Approve Regulatory Document

**REGDOC-2.9.2,
*Environmental
Protection: Controlling
Releases to the
Environment***

- REGDOC-2.9.2, *Environmental Protection: Controlling Releases to the Environment*
- comments dispositioning table

Figure 1: Conceptual relationship between an upper value of normal operation for a nuclear or hazardous substance, an action level, and a licensed release limit.

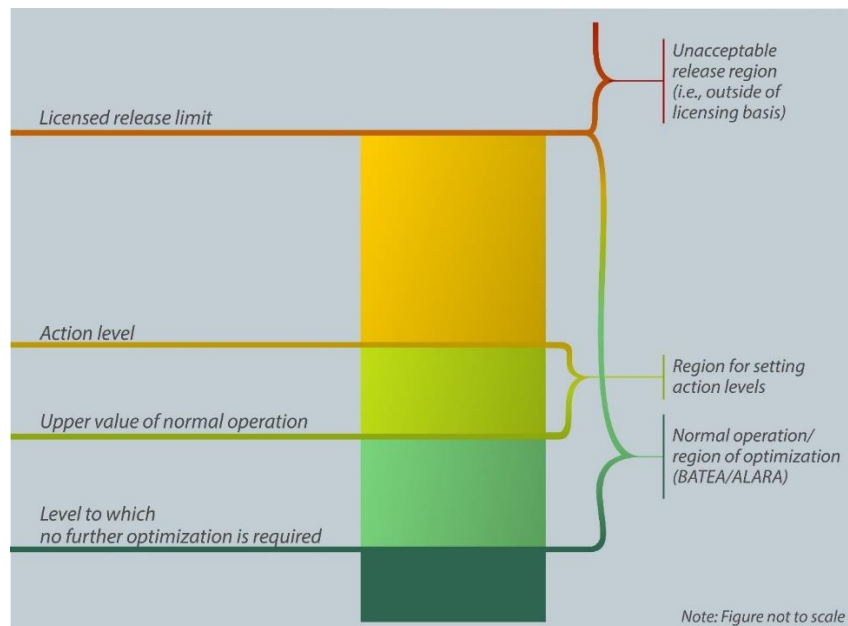
7.	CNA, OPG, Hydro-Quebec, Bruce Power, CNL, NB Power and Cameco.	Submit comments on section 2.1 and 2.1.1	<p>Industry Issue: Clarification</p> <p>The 1st sentence beneath Figure 1 could be interpreted to require optimization beyond 10 uSv/year. Previous sections refer to 10 µSv/yr as the “de-minimus” dose, representing levels in which no further regulatory control is necessary. As written, this introduces the potential for misapplication of the optimization principle – or misinterpretations of the requirements by licensees or other stakeholders.</p> <p>Suggested Change:</p> <p>Revise to read, “...doses approximating 10 µSv/year are recommended as the level below which further optimization and application of BATEA is no longer necessary”</p>	<p>Text Moved to Appendix B</p> <p>Text will be updated to read,</p> <p>“When applying the concept of optimization to establish licensed release limits, modelled doses approximating 10 µSv/year are recommended as the lower boundary for requiring level below which further optimization and application of BATEA is no longer necessary.”</p>

Figure 2: Release performance data for a quantity or concentration of a sample nuclear or hazardous substance over time

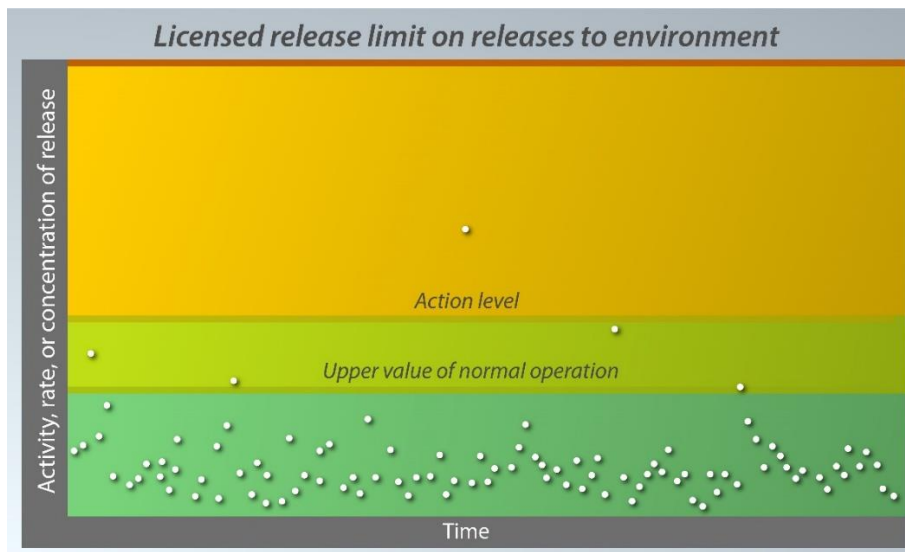
12.	CNA, OPG, Hydro-Quebec, Bruce Power, CNL, NB Power and Cameco.	Submit comments on section 2.2	<p>Industry Issue: Clarification As per Theme #2, Figure 2 is very similar to Figure 1 in CSA N288.8-17 and should be referenced for consistency. There are two different regions in Figure 2 that describe normal operations – “upper value of normal operation” and “Normal Operation/region of optimization (BATEA/ALARA),” which may create confusion. Figure 2 shows that the “maximum predicted design release” should be the same as the licensed release limit.” This is not practicable as the maximum of normal operations likely falls between the upper value of normal operations (e.g., 95th percentile) and the action level based on N288.8-17. This would result in a licensed limit below the action level.</p> <p>Suggested Change: Revise Figure 2 to align with Figure 1 in CSA N288.8-17 and reference this</p>	<p>These figures are not entirely the same.</p> <p>Appendix B.2 has now been created to describe the relationship between environmental release targets, maximum predicted design release, and licensed release limits.</p> <p>For clarity, the term “maximum predicted design release” has been removed from Figure 2.</p>
